Access Compliance Report

Public Rights-of-Way

(Curb Ramps)

Intersection ID: 54457	Main Street: FORNEY_CT	Cross Street: RUPELL_DR	Location: NE
ADA ID: F94242458251	Ramp Type: BlendTrans1	Initial Pass/Fail: Fail	Overall Compliance: No
Severity Score: 8.75			
Codes/Mitigation Info/Possible Solution		Field Measurements/Component Compliance

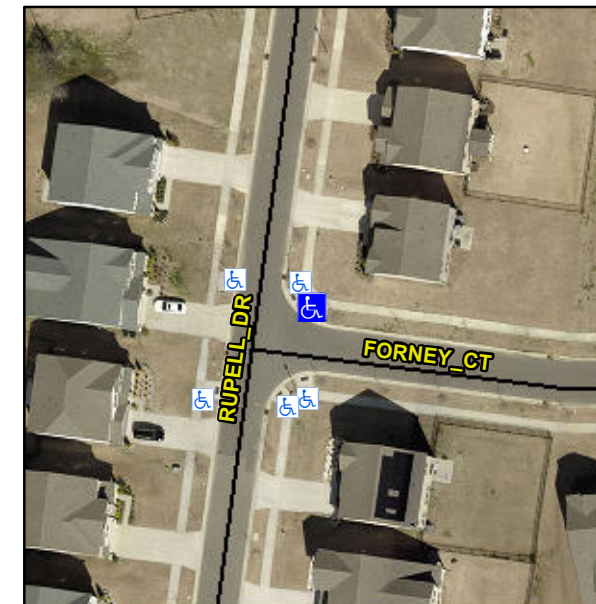
Not Found, R304.5.1

Compliance	Description	Data	Compliance	Description	Data
N/A	Ramp Length (in)	96.0	Yes	BlendTrans Slope (%)	2.1
No	Ramp Width (in)	47.0	Yes	BlendTrans XSlope (%)	0.8
N/A	Flare Type LT	N/A	N/A	Flare Type RT	N/A
N/A	Flare Slope LT (%)	N/A	N/A	Flare Slope RT (%)	N/A
N/A	Flare Traversable LT?	N/A	N/A	Flare Traversable RT?	N/A
N/A	Landing Length (in)	N/A	N/A	DWS Provided?	N/A
N/A	Landing Width (in)	N/A	N/A	DWS Contrast?	N/A
N/A	Landing Slope (%)	N/A	N/A	DWS Length (in)	N/A
N/A	Landing X Slope (%)	N/A	N/A	DWS Full Width?	N/A
N/A	Landing Curb? (Y/N)	N/A	N/A	DWS Offset (in)	N/A
N/A	Shared Landing?	N/A			
N/A	Gutter Ponding?	N/A	N/A	Gutter Slope (%)	N/A
N/A	Gutter Lip Ht (in)	N/A	N/A	Gutter X Slope (%)	N/A
N/A	Painted X Walk1?	No	N/A	Painted X Walk2?	N/A
	X Walk 1 Direction	To S		X Walk 2 Direction	N/A
	X Walk 1 Width (in)	N/A		X Walk 2 Width (in)	N/A
	X Walk 1 Slope (%)	1.3		X Walk 2 Slope (%)	N/A
	X Walk 1 X Slope (%)	0.6		X Walk 2 X Slope (%)	N/A

N/A	Ramp inside XWalk1?	N/A	N/A	Ramp inside XWalk2?	N/A
	Road Slope (%)	0.6		Clear Space?	N/A
	Road X Slope (%)	1.3	N/A	Clear Space to XWalk (in)	N/A
N/A	Any Obstructions?	N/A	N/A	Storm Grate/Utility Hazard?	N/A
	Obstruction Type			Storm Grate/Utility Type	
		N/A			N/A
			Yes	Surface Condition? (G/P)	Good
			No	Curb Slope (%)	7.3

Remove & Replace Curb Ramp With Two New Directional Ramps or Equivalent.
